| Title: Capacitor Cavalon | | Compliance Category: A - MANDATORY B - RECOMMENDED C - OPTIONAL |
| AG-SB-2018-02-B-EN | Applicability | |
| Aircraft type & model: Cavalon with a Super B Battery, in which the Service Bulletin AG_MI_2014_05_C was not executed | Affected Serial number(s): | |

Reason and overview of the Service Bulletin (cause of problem if known)

fig 1: fuse carrier (a), no capacitor

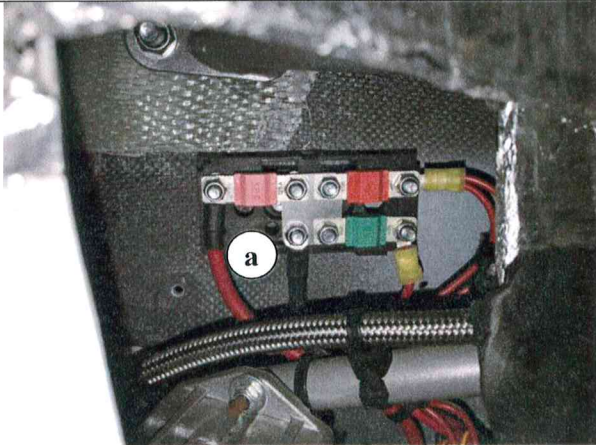
Check if a capacitor is already installed (see fig. 1 and 2).

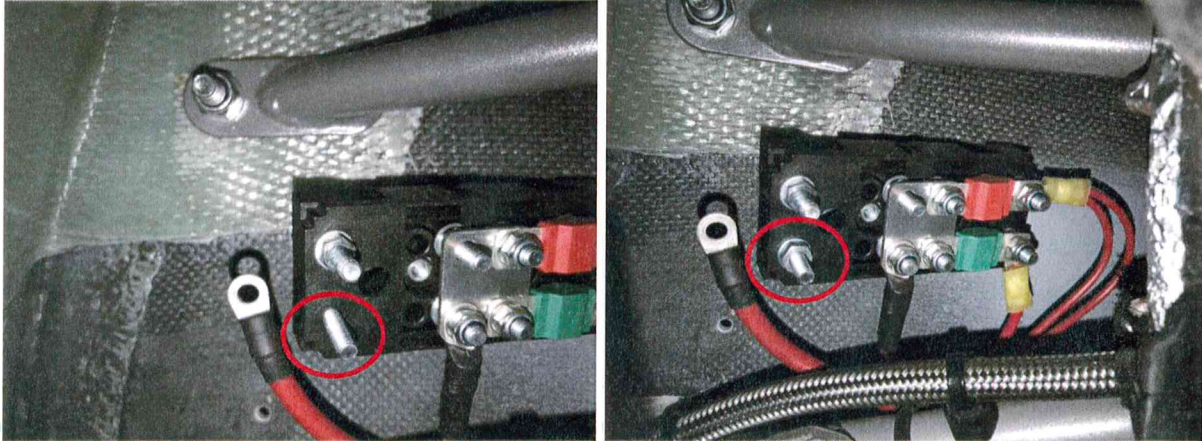
4. Remove the cable at the top left on the fuse carrier

5. Fit the new M5x25 screw from the rear of the fuse carrier (left bottom) and secure it with a washer (U5) and nut (M5). Take care when tightening, do not break the plastic carrier!

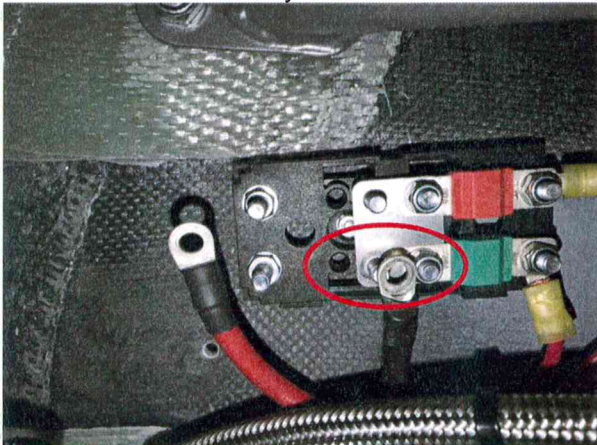
6. Replace the fuse holder on the fire wall and secure the screws with loctite blue

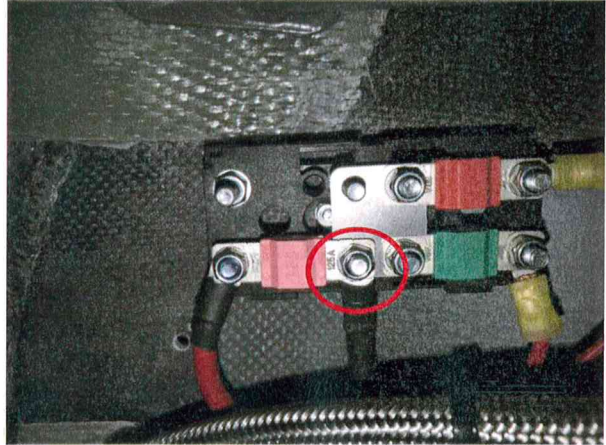
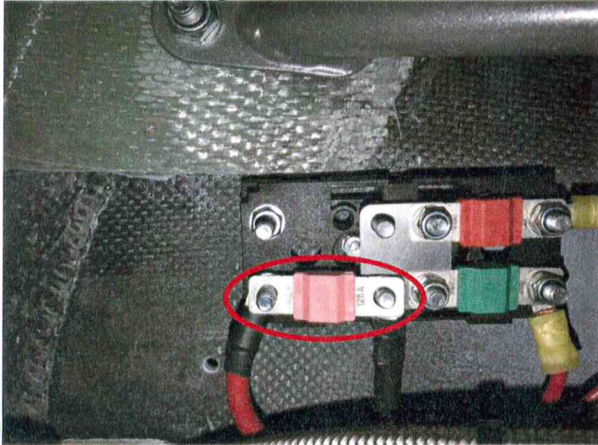
7. Loosen the battery cable at the fuse carrier (middle left bottom)

8. Insert and tighten 125A fuse (starter)

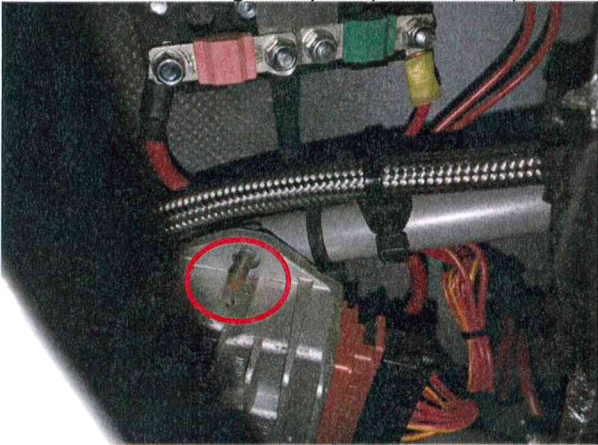
9. Attach the negative pole (black cable) of the capacitor to the charge controller fastening

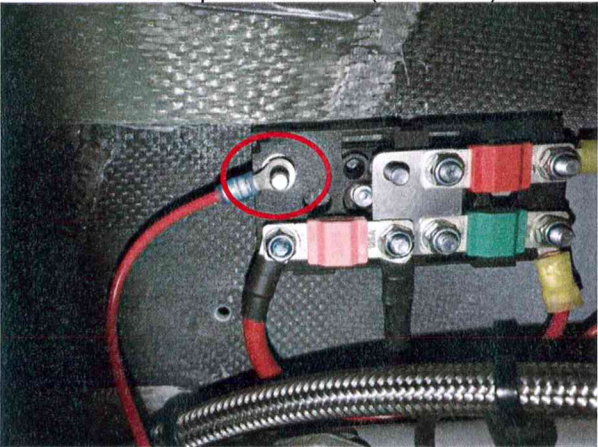
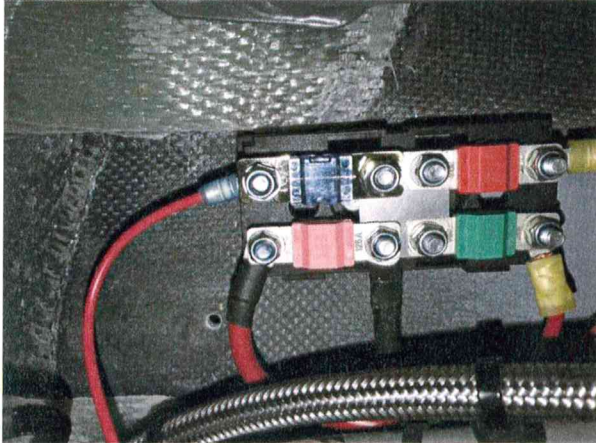
10. Attach the positive cable (red cable) of the capacitor to the fuse carrier on the top left

11. Insert and tighten 10A fuse
